ADDENDUM NO. 4  
TO THE  
DRAWINGS AND PROJECT MANUAL  
FOR  
**NEW OPPORTUNITY AWARENESS CENTER  
KATY INDEPENDENT SCHOOL DISTRICT  
KATY, TEXAS**

06/17/2026

#### CIVIL CONSULTANT, ADDENDUM No. 4

**C5.00**

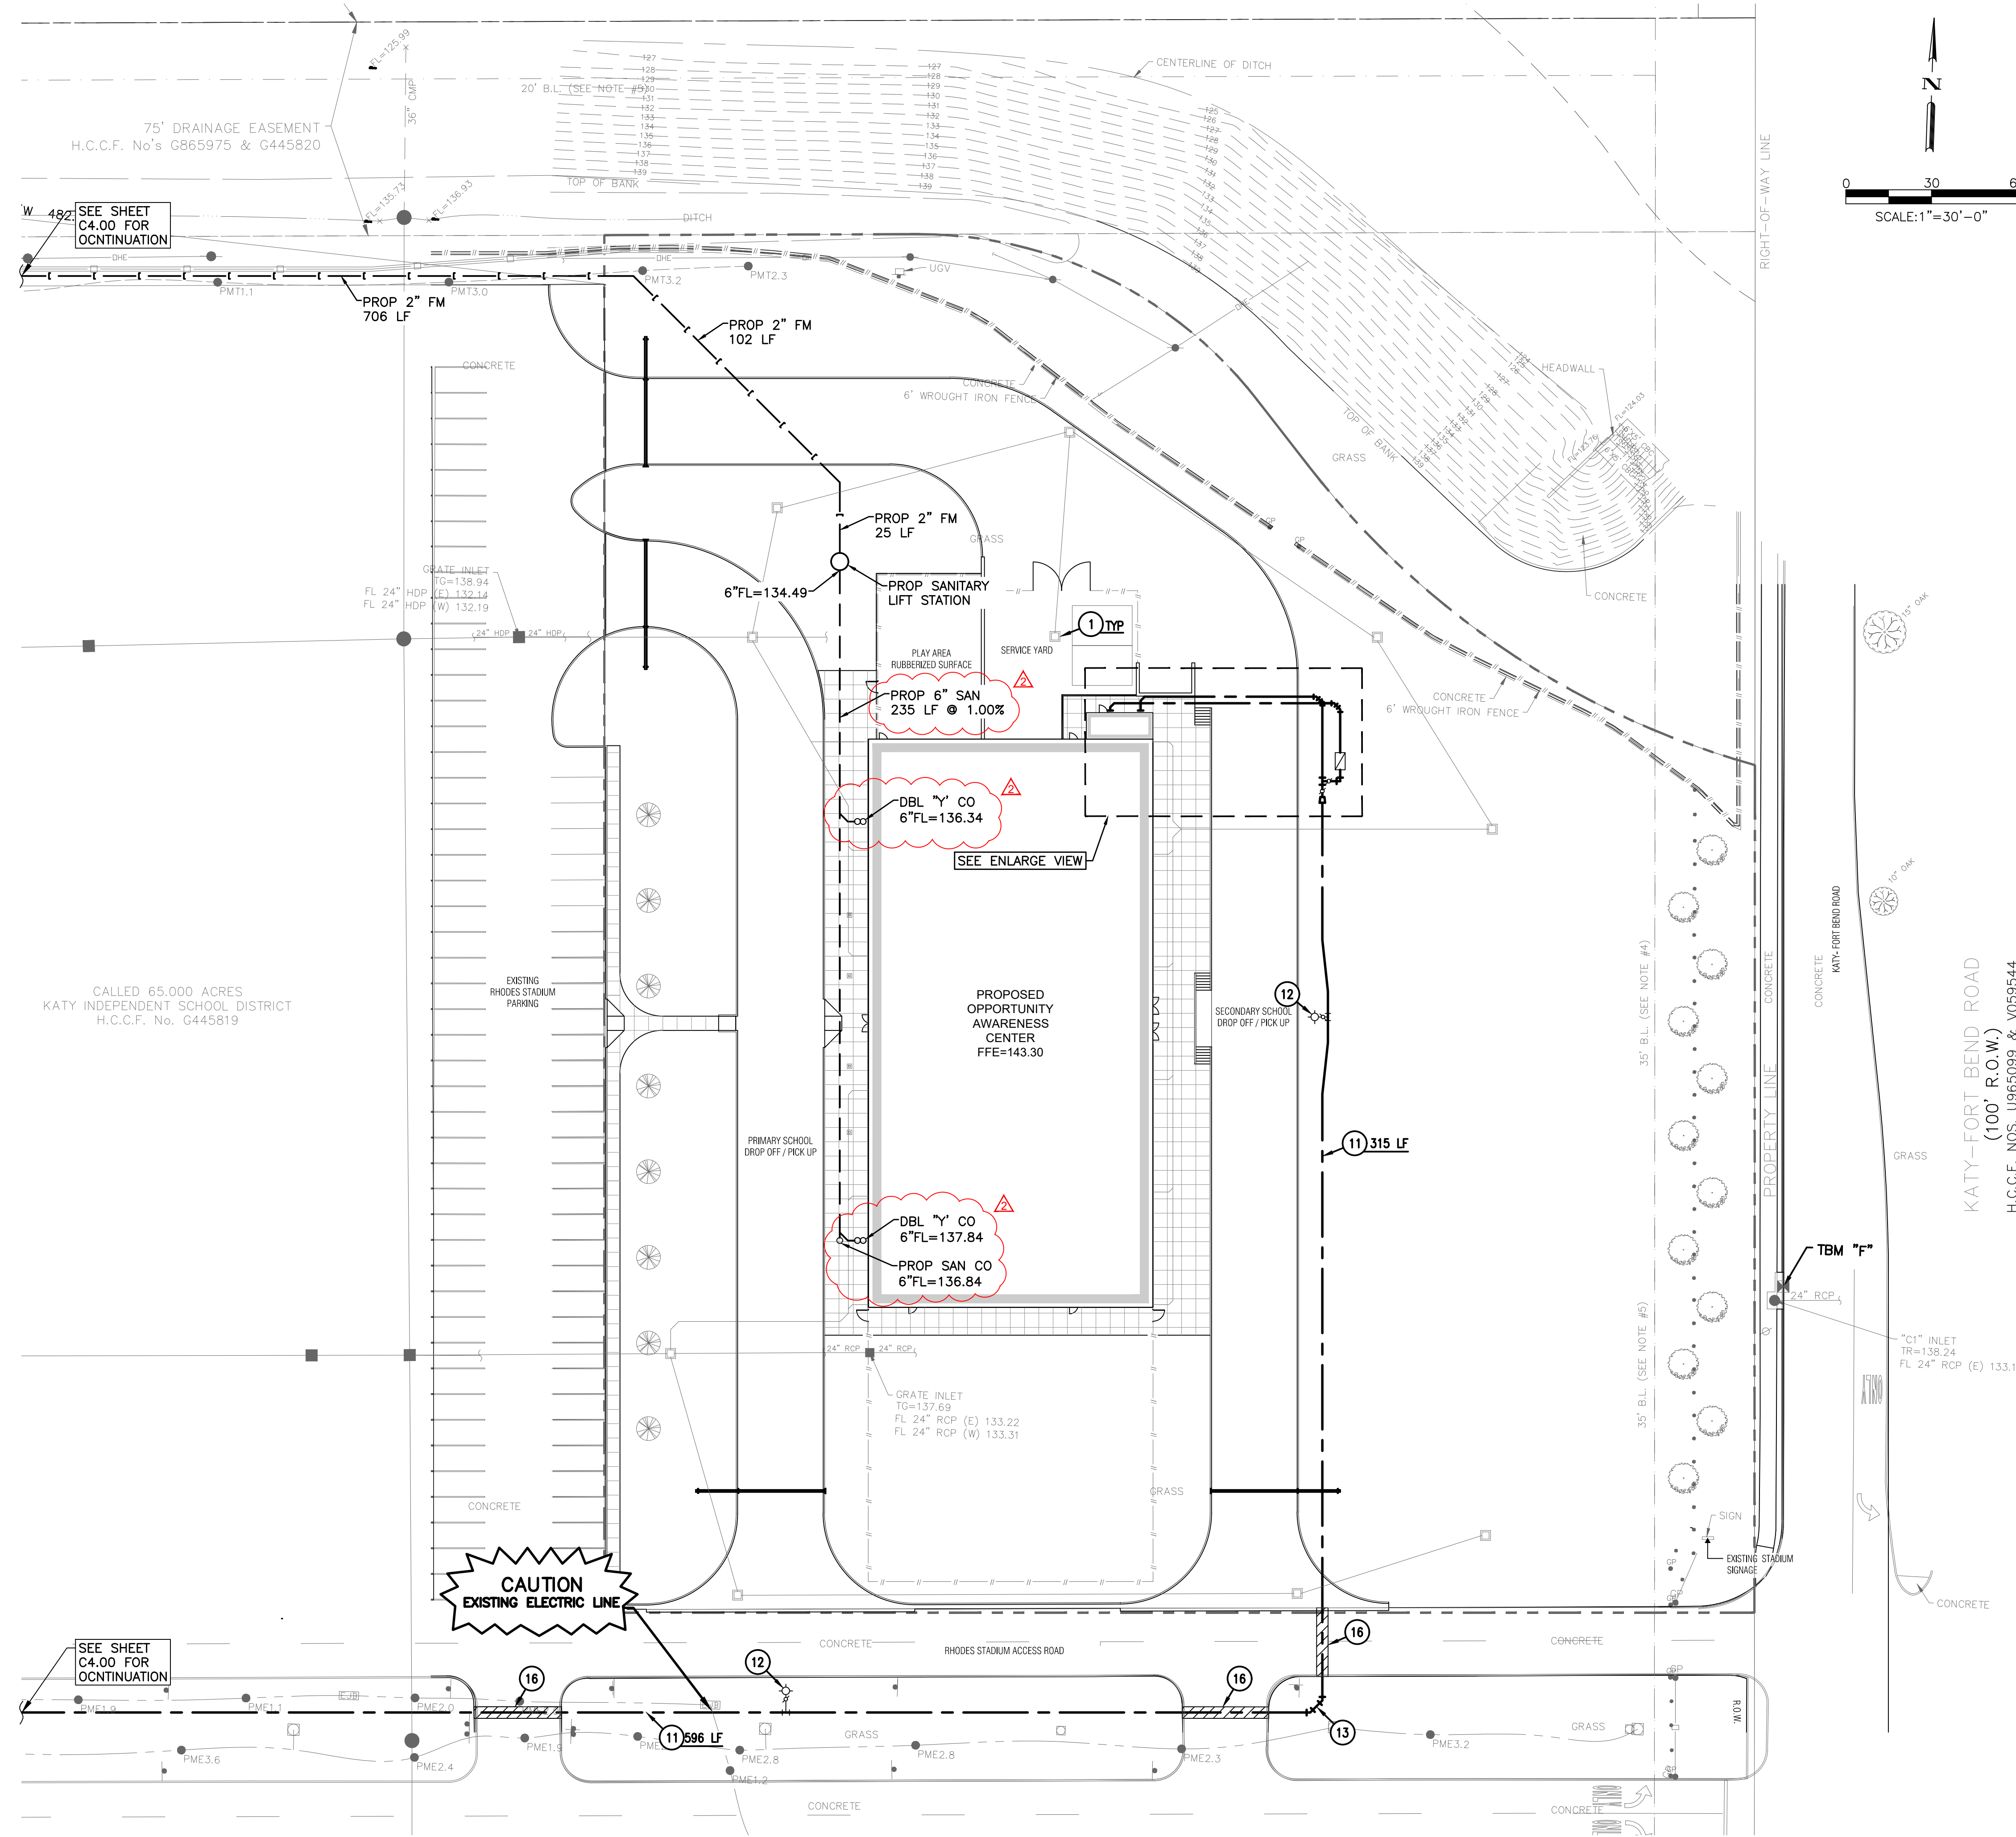
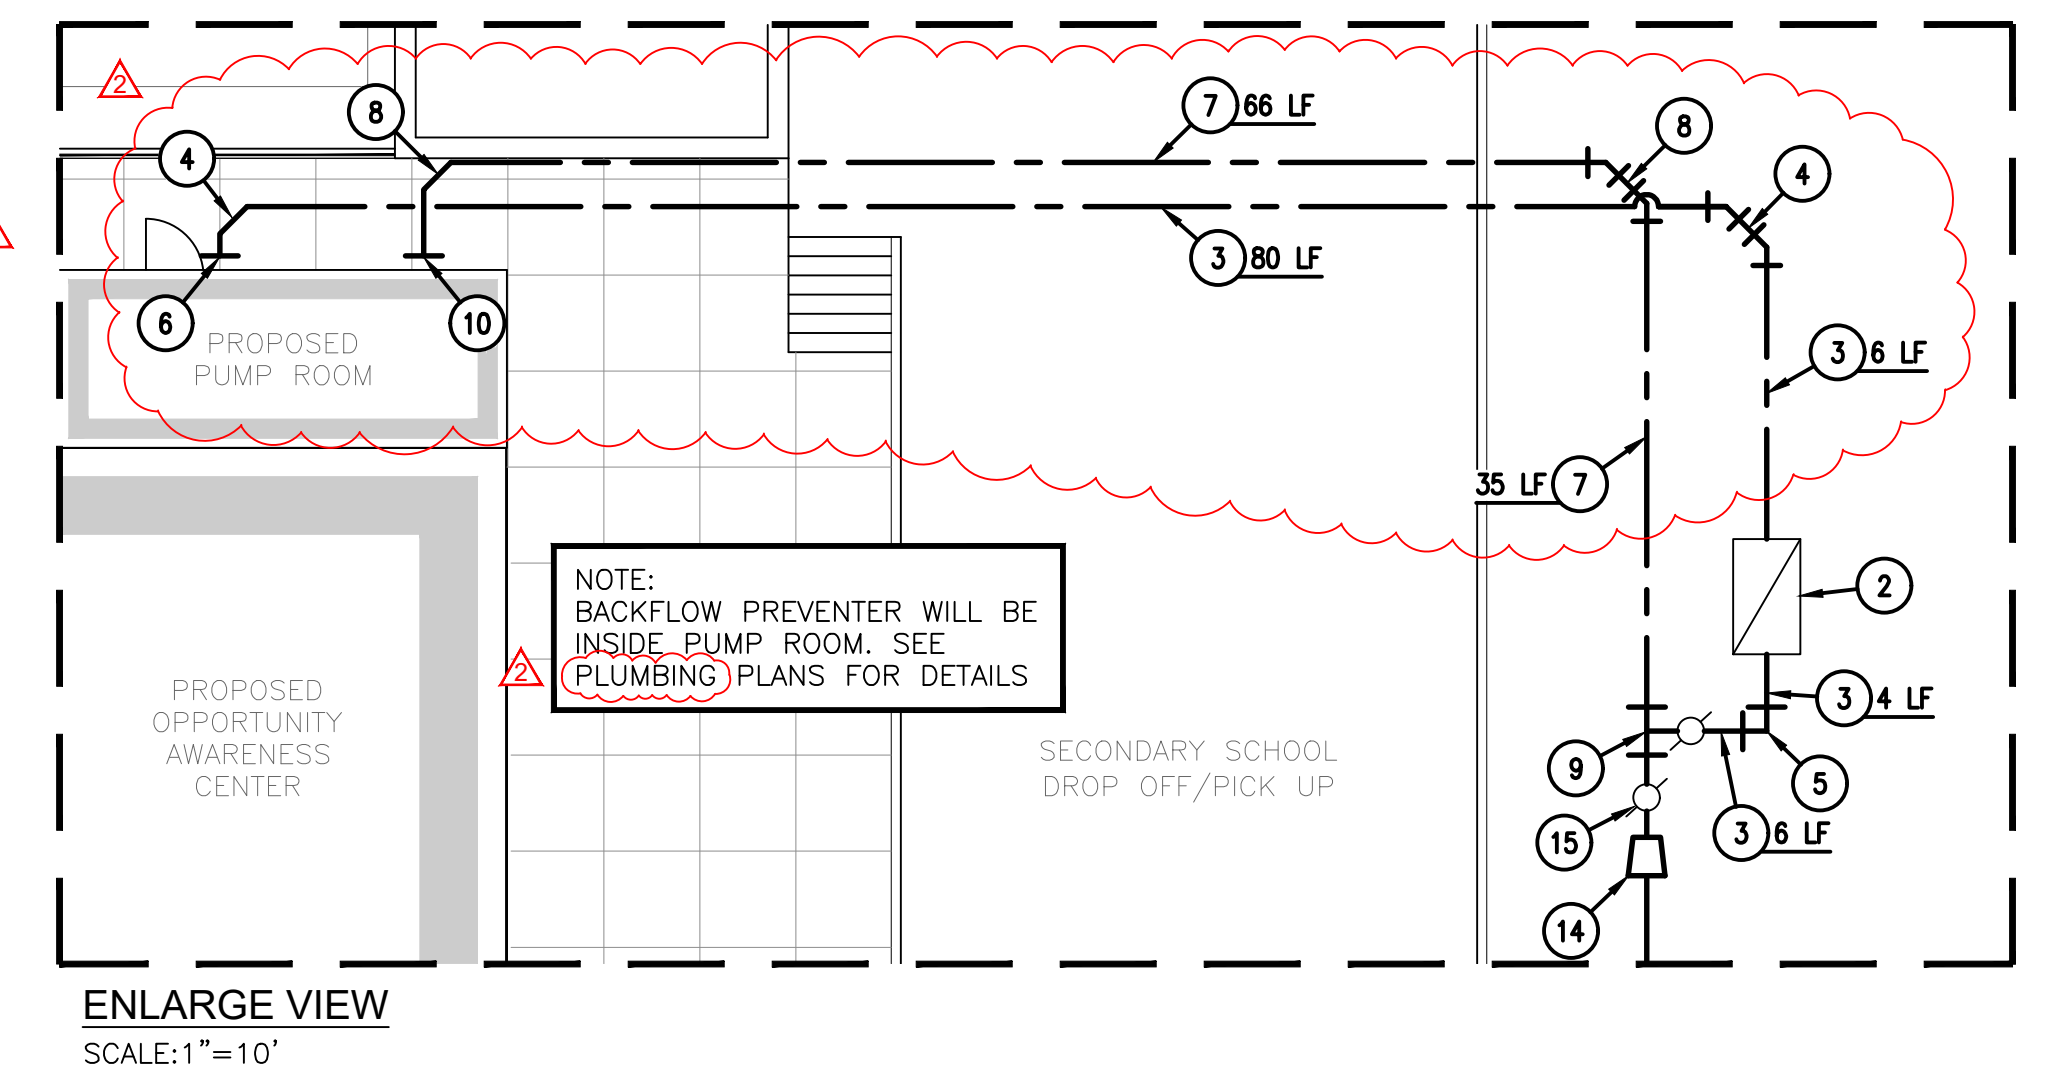
##### 4. C5.00 - SITE UTILITY PLAN

- A. Revised 4-inch domestic water line (C900 PVC) to 3-inch domestic water line (SCH 40 PVC) to match plumbing plans. Updated key notes 2, 3, 4, 5, 6, and 9 to show 3-inch.
- B. Revised 6-inch fire line connection and 3-inch domestic water line connection to pump room, to match plumbing plans.
- C. Revised sanitary connection points and length of sanitary line along west side of building to match plumbing plans.
- D. Revised backflow preventer reference note to see plumbing plans instead of fire engineer plans for details.

**1 MECHANICAL LEVEL ONE FLOOR PLAN**  
SCALE = 1/8" = 1'-0"

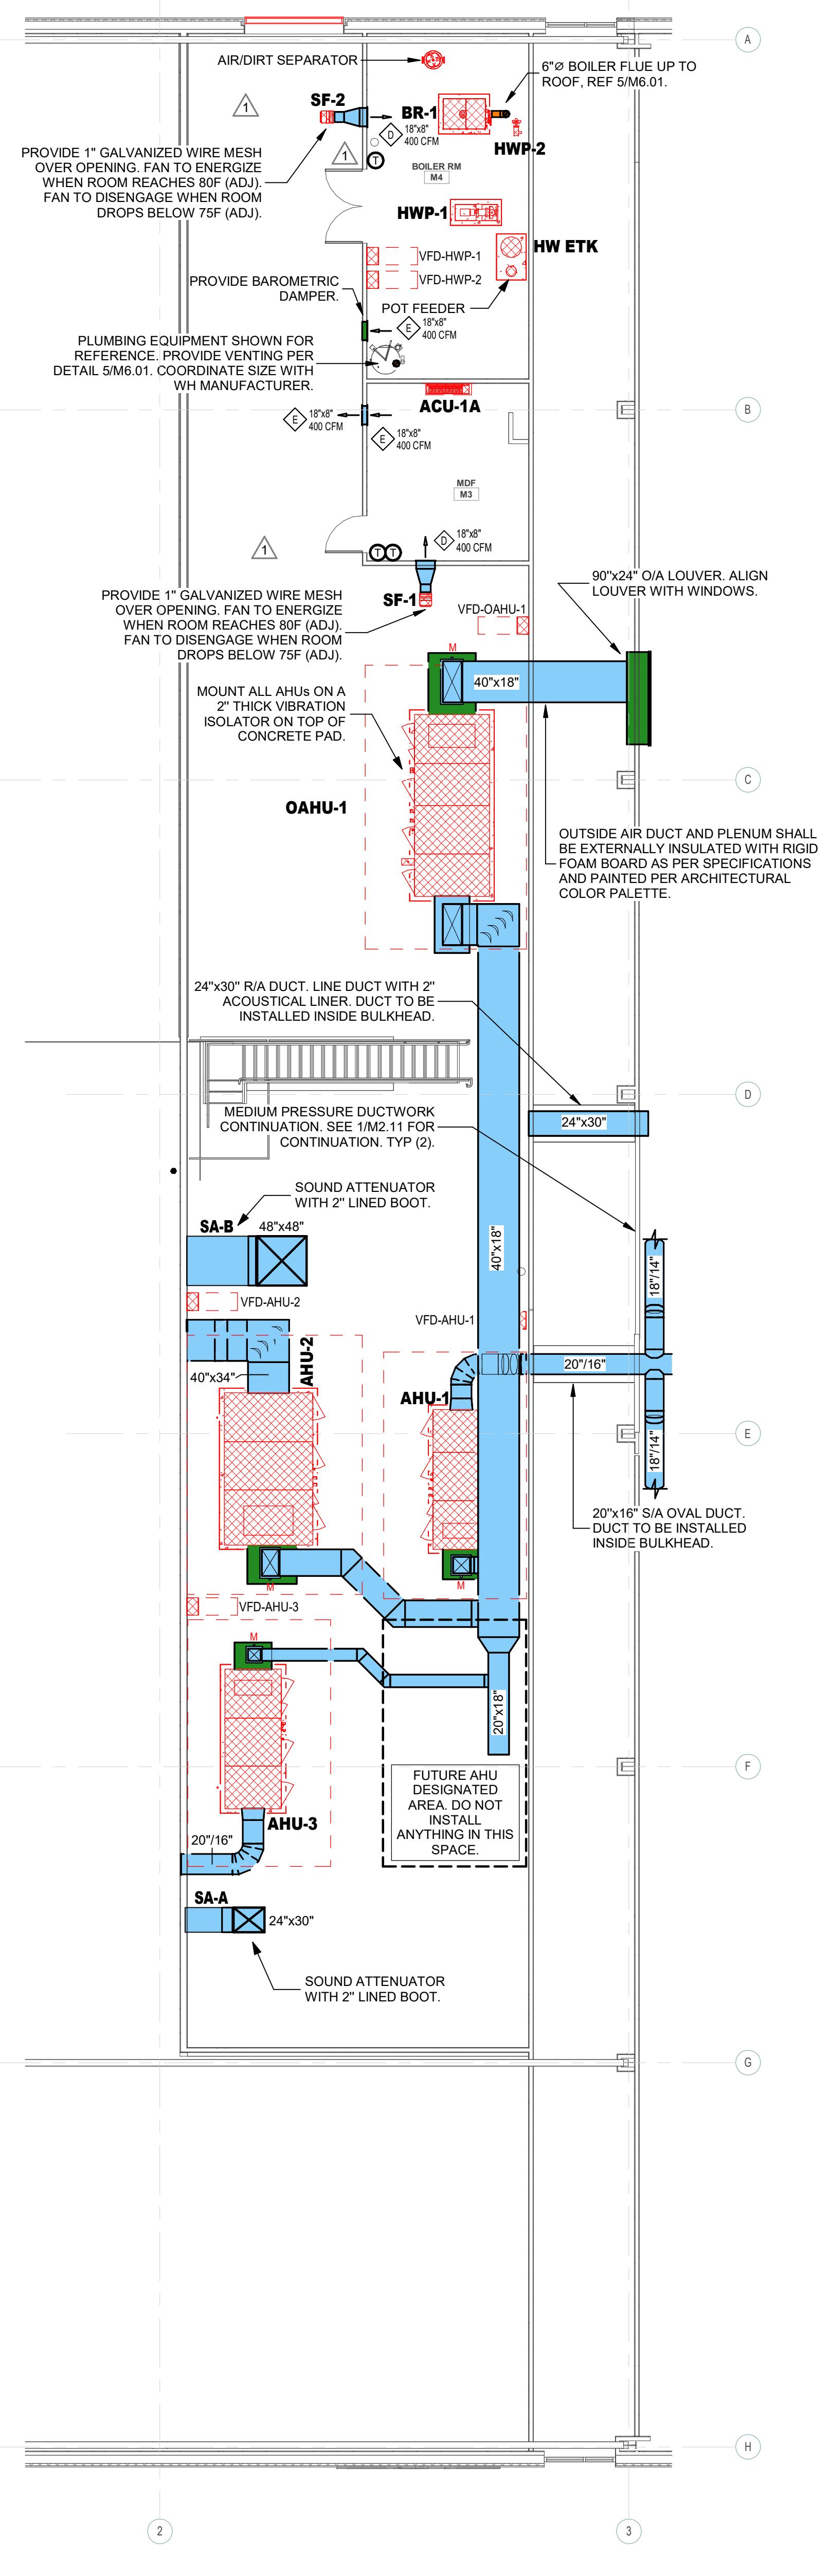
##### 1. SHEET M2.11 – MECHANICAL LEVEL ONE FLOOR PLAN

- A. Added exhaust ductwork and a ventilator for dryer.
- B. Added keynote 5.
- C. Added grilles for a finished look on the storage rooms.

M7.01

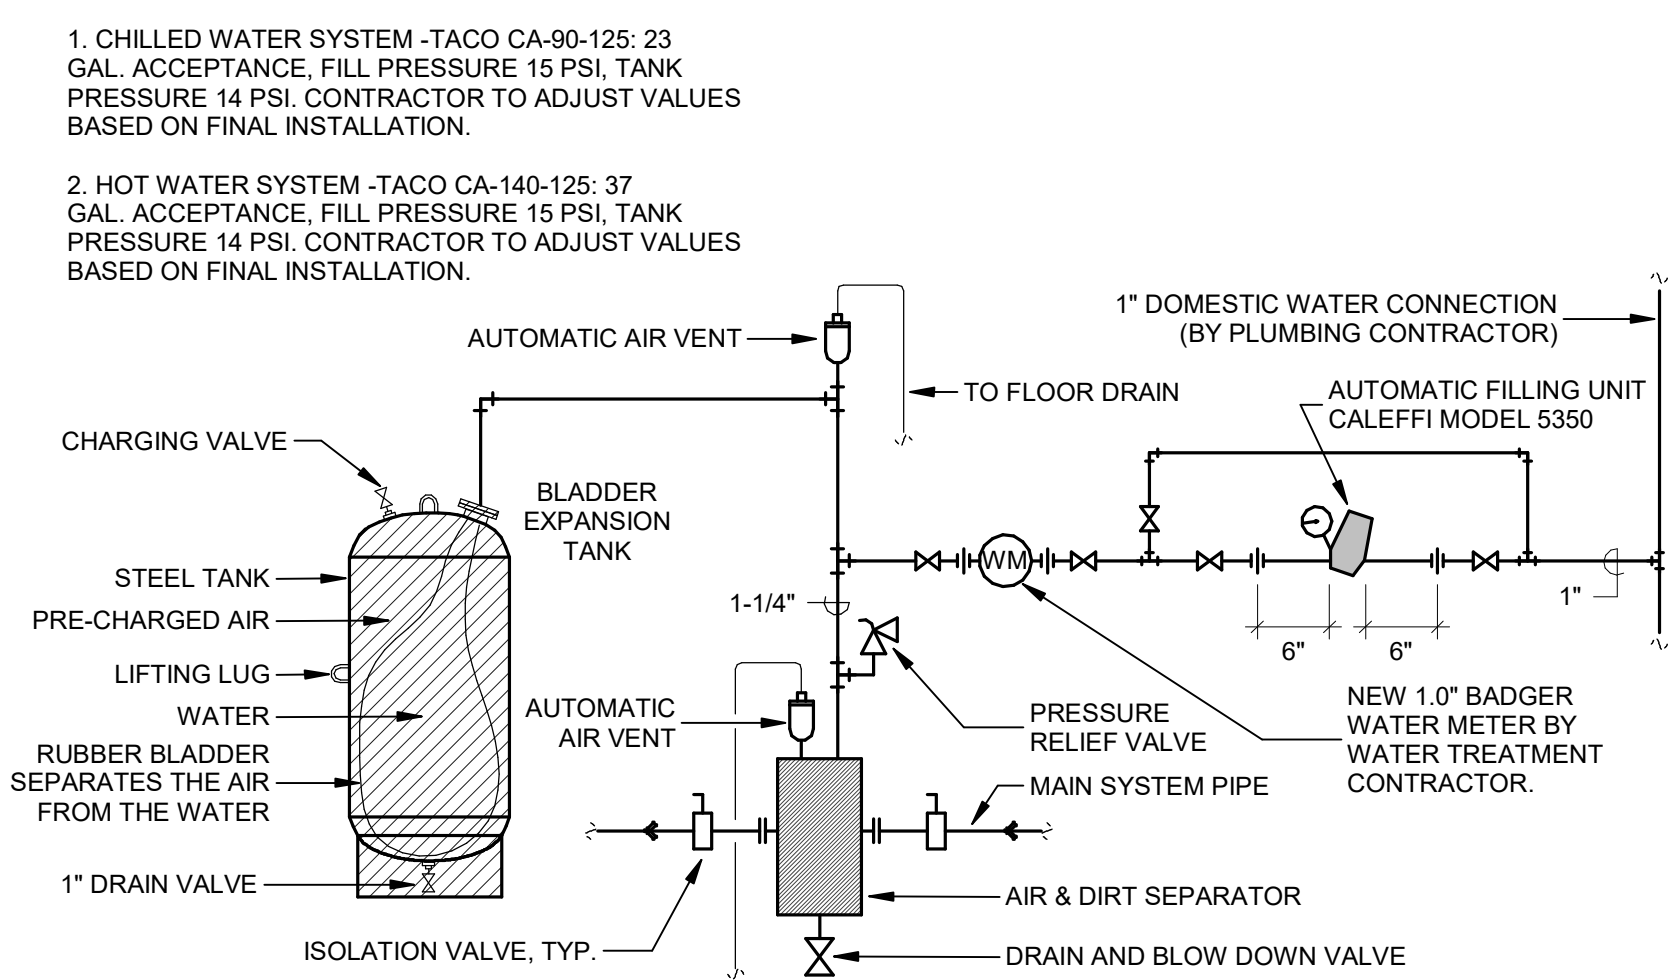
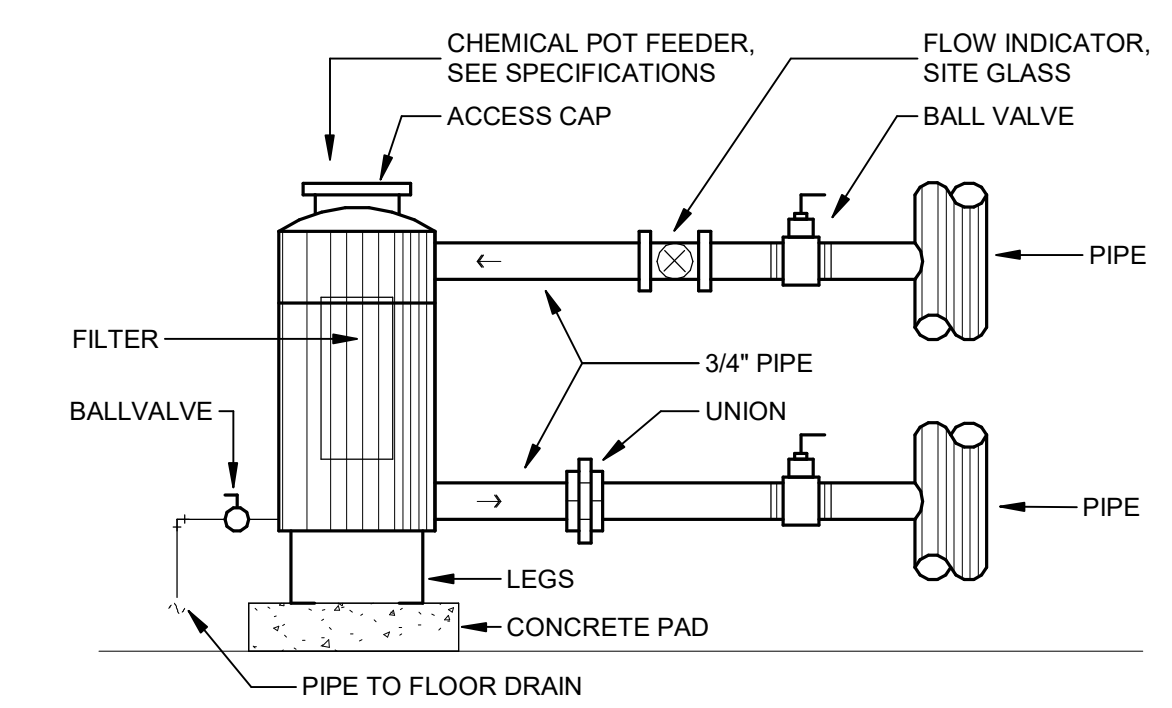
##### 4. SHEET M7.01 – MECHANICAL SCHEMATICS

- A. Added note on expansion tank for chilled water expansion tank.
- B. Added note on expansion tank for hot water expansion tank.
- C. Relocated air/dirt separator.
